SERVICE POINTER

L8178627
January 2007

MAYTAG FRONT LOAD WASHER AND STACKED LAUNDRY PRODUCTS

GRINDING NOISE

Figure 1

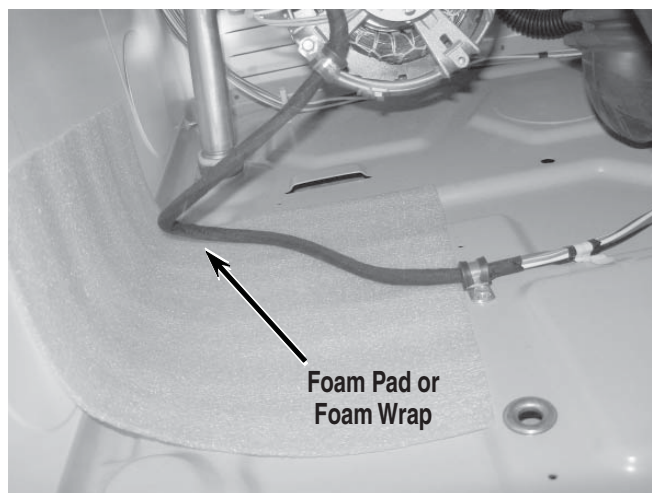
Grinding noise.

Motor wiring harness is vibrating against the washer base.

Apply a foam wrap or foam pad between the motor wire harness and the base. See *Figure 1*.
